TransAtlantic TA-30 Reverb & FX Noise Mod

Mesa/Boogie Tech Bulletin

TA-30 <u>HEAD ONLY</u> Reverb Hum Update July 2013

September 2013 Mesa/Boogie Tech Bulletin TA30 Buzz/Dropout Update

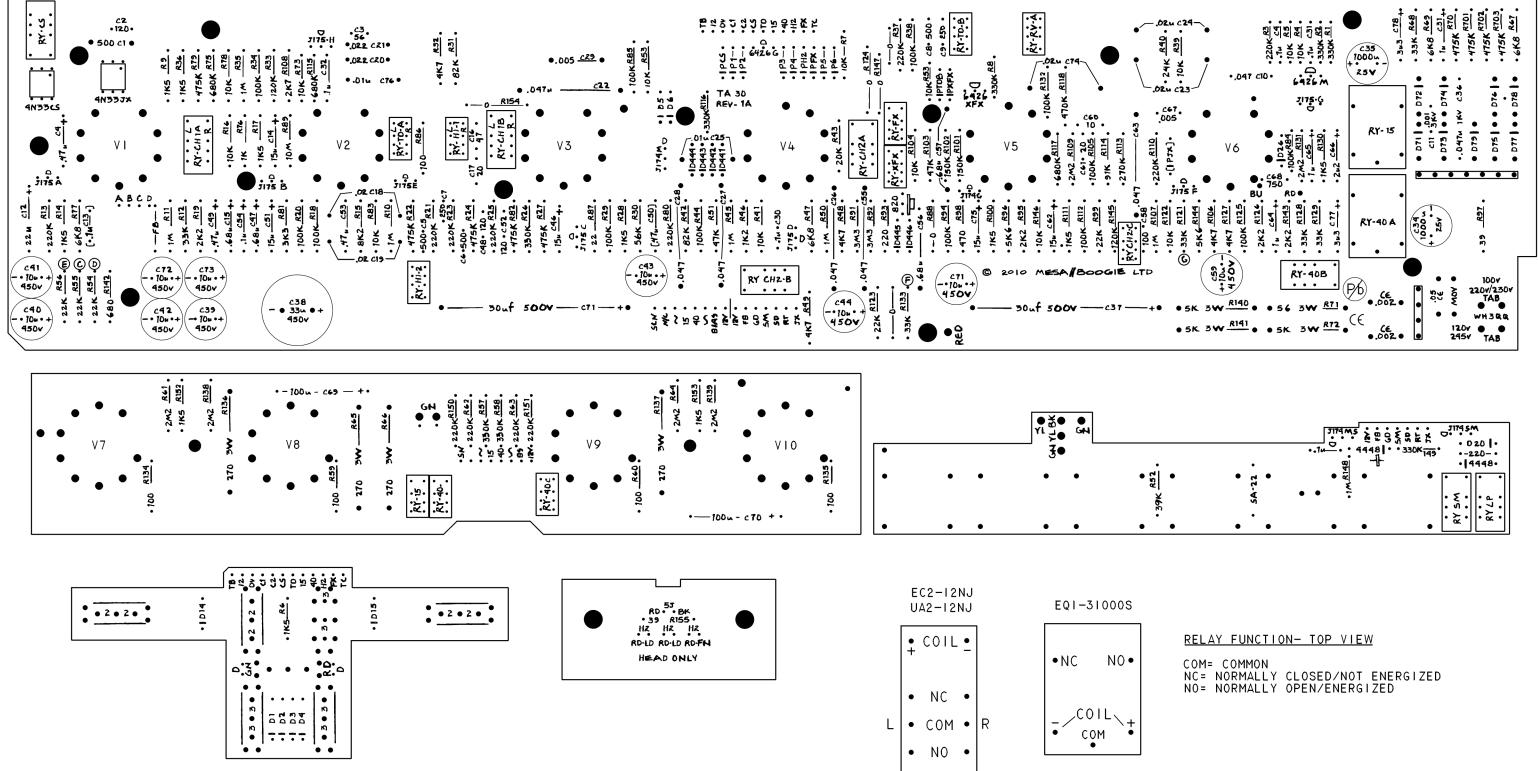
This mod reduces hum and noise generated by a trace on the rear panel board picking up hum from the Reverb Circuit when the FX/Reverb is on. This mod abandons the trace on the circuit board in favor of a hardwired shielded wire and associated components:

2) Place the 22k resistor between the hot and ground of the reverb return jack. One end of the 10K will connect with the hot of the shielded cable - the other connects to the hot of the jack, shared with the 22K. Attach the hot of the shielded cable to the 10K and the shield to ground lug of reverb return jack. Finally, retack the gray reverb ftsw wire back into place.

3) Lift pin #2 of V6 by placing probe behind the pin and lifting out while unsoldering.

4) Remove old J175 and install the long lead J175 and lay the non-grounded leg over pin #2 of V6.

5) Route and solder the other end of the 14" shielded cable. The hot goes to pin #2 (upper arrow) and the shield goes to PC board ground at the 220k and J175-F node (lower arrow).

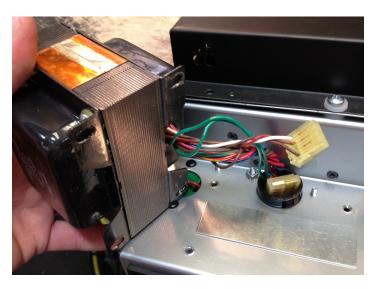
This update reduces excess hum at higher reverb settings in TA-30 Heads below serial number 2900. The update involves remounting the power transformer with a new mounting bracket.

- 1. Remove the screws for the lid (4 on each side). Carefully lift the lid partially off. There are 3 connectors for the fan and display leds that plug in next to the power transformer. Note their connection and orientation before lifting them off.
- 2. Turn the chassis over and remove the bottom. (10 screws total).
- 3. Remove the tie wraps from the green filament wire bundle and the two power transformer header wire bundles (shown right).
- 4. Mark one of the green filament wires for location (they are trimmed for length), and then unsolder them both. Lift the two transformer headers from the circuit board, noting their orientation.
- 5. Remove the 4 power transformer mounting screws and nuts and remove the power transformer. The larger secondary header will fit through the chassis hole sideways. Note where the heatsink plate was located under the transformer.

6. Remove the grommet and replace with the new one as shown and place the heatsink plate back in its original position (shown right).

7. Place the two countersunk bolts in the bottom vertical holes of the new mounting bracket and install the bracket using the original transformer mounting bolts and nuts (shown right).

- 9. Remount the transformer as shown. Use the #8 lock nuts for the two lower countersink screws. Pushing inward on the nut driver will help stabilize the screw so that the nut can be tightened. Use the two #10 bolts, washers and nylon nuts for the top two mounting holes. Mounting the nuts on the bottom side of the bracket will make it easier to tighten the screws. Tighten all nuts very securely. Remove the masking tape once the transformer has been tightened.
- **10.** Reinstall the two transformer headers, and resolder the two green filament wires to their original position.
- **11.** Neatly bundle and tie wrap the filament wires and the transformer header wires to their original position.
- 12. Reinstall bottom cover and lid.

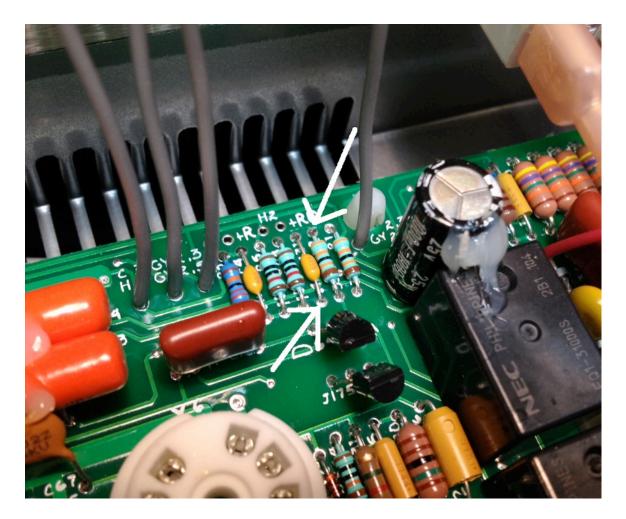
Symptom: Amp will buzz when switched to 40W or 15W modes. Also, amp may lose sound intermittently, and switching wattage switch will bring it back.

Fix: Add a 2.2kuf 25V electrolytic filter cap to the +15V supply, Mesa Part #525224.

Solder the filter cap to the two points shown (V6 removed for clarity). The negative end connects to the rear end of C31, and the positive end connects to the forward end of R2. Add silicone glue for support. See pictures for reference.
